# Access Compliance Report Public Rights-of-Way (Curb Ramps)

Main Street: CORPORATE\_DR Cross Street: CORPORATE\_DR Location: E

ADA ID: RPRK211116122407 Ramp Type: Type 4 - Parallel Initial Pass/Fail: Fail Overall Compliance: No Severity Score: 2

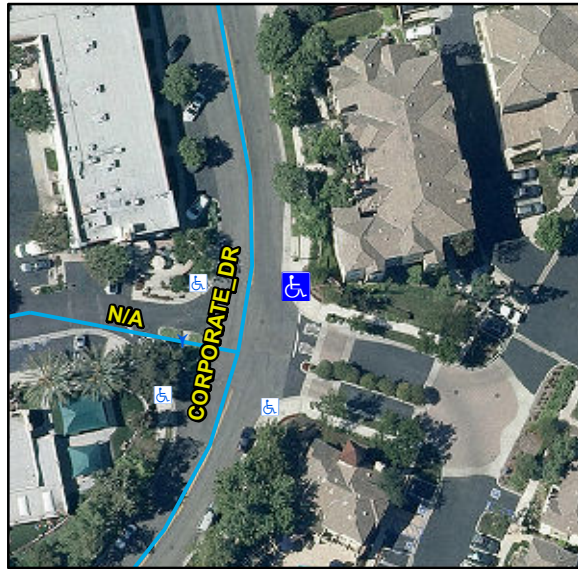
### Surveyor Notes:

N/A

| Compliance | Description                   | Data       | Compliance | Description                   | Data |
|------------|-------------------------------|------------|------------|-------------------------------|------|
| No         | Ramp Cross Slope LT (%)       | 2.6        | No         | Ramp Cross Slope RT (%)       | 2.3  |

Remove & Replace Curb Ramp With Two New Directional Ramps or Equivalent.

R204.3, R304.5.3, STD 1115
